UNITED STATES PATENT AND TRADEMARK OFFICE

Office Action Summary

10/585,919

NAGATA, TATSUHIKO

- 1st modified fig. 4 -

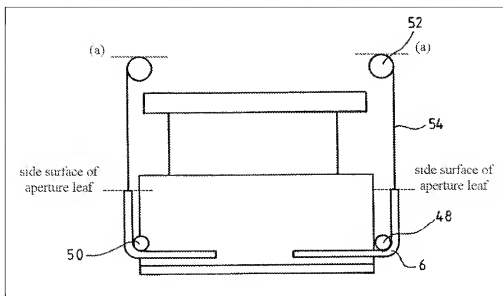
- Regarding claim 1, Saladin et al. teaches an irradiation field limiting device which shields radiation from a radiation source (38) by driving a plurality of aperture leaves (4, 6, 8, 10), arranged in a thickness direction (see figs. 2 and 4), a specific amount to limit an irradiation field to a desired range (para 0013), the irradiation field limiting device comprising:

- a flexible linear member (54) secured to a thick portion of the aperture leaf (fig. 4; para 0019, lines 16-17) and provided such that the linear member can be bent along a side surface of the aperture leaf (as the linear member 54 is wound onto the drum 52, examiner takes the position that at least at point (a), shown in 1st modified fig. 4 the linear member is being bent *along* the side surface of the aperture leaf) on a side of the radiation source (see figs. 2 and 4); and

- Regarding claim 8, Saladin et al. teaches that the aperture leaf is rectangular (see figs. 1 and 4; para 0020, first sentence).
- Regarding claim 12, Saladin et al. teaches that the aperture leaves are arranged in a thickness direction (see figs. 2 and 4) so that the aperture leaves can freely move through rolling elements (48, 50), and wherein the side surface of the aperture leaf protrudes in the thickness direction to form a holding portion which holds the rolling element (see 1st modified fig. 4 above).

- 2nd modified fig. 4 -

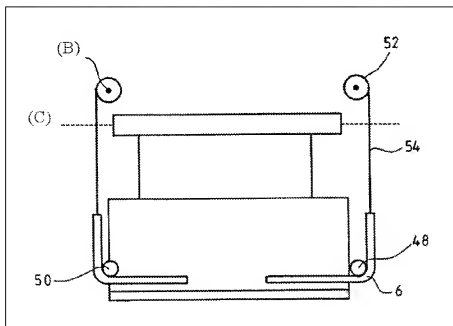
- Regarding claim 18, Saladin et al. teaches that the linear members respectively secured to the aperture leaves adjacent in the thickness direction differ in axial direction (as shown in the 2nd modified fig. 4 below, the axial direction (B), perpendicular to the plane of the figure, of the linear members 54 of the aperture leaves 6 and 10 differ from the axial direction (C) of the linear members 54 of the aperture leaves 4 and 8. To further support this position, examiner would like to point to paragraph 0019, lines 17-18 which states, "... wires 54, which are secured to the shutters to be wound onto the drums").

- Regarding claim 19, Saladin et al. teaches that the driver section drives the aperture leaf (para 0019, last sentence; para 0014, lines 6-10) of which the axial direction of the linear member is set to be identical in units of a specific number of the linear members (as shown in the 2nd modified fig. 4 above, the axial direction of the linear member 54 of aperture leaf 6 is

identical to the axial direction of the linear member 54 of aperture leaf 10; and the axial direction of the linear member 54 of aperture leaf 4 is identical to the axial direction of the aperture leaf 8).

- 3rd modified fig. 4 -

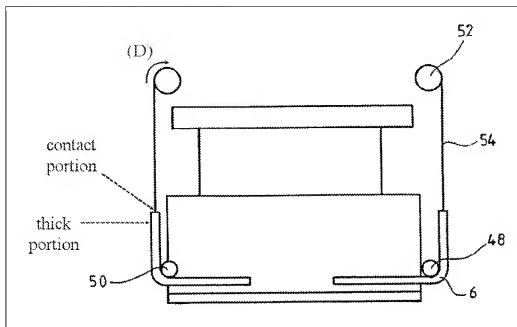
- Regarding claim 22, Saladin et al. teaches that the linear member drives the aperture leaf while contacting the thick portion (fig. 4; para 0019, lines 16-17; see 3rd modified fig. 4 below), is preliminarily bent in a direction away from a contact portion between the linear member and the thick portion (see 3rd modified fig. 4 below), and presses a portion (52) in contact with the thick portion (via the linear member 54) so that the linear member is prevented from buckling (the tension created in the linear member as a result of being wound onto the drum 52 prevents buckling of the linear member; para 0019).
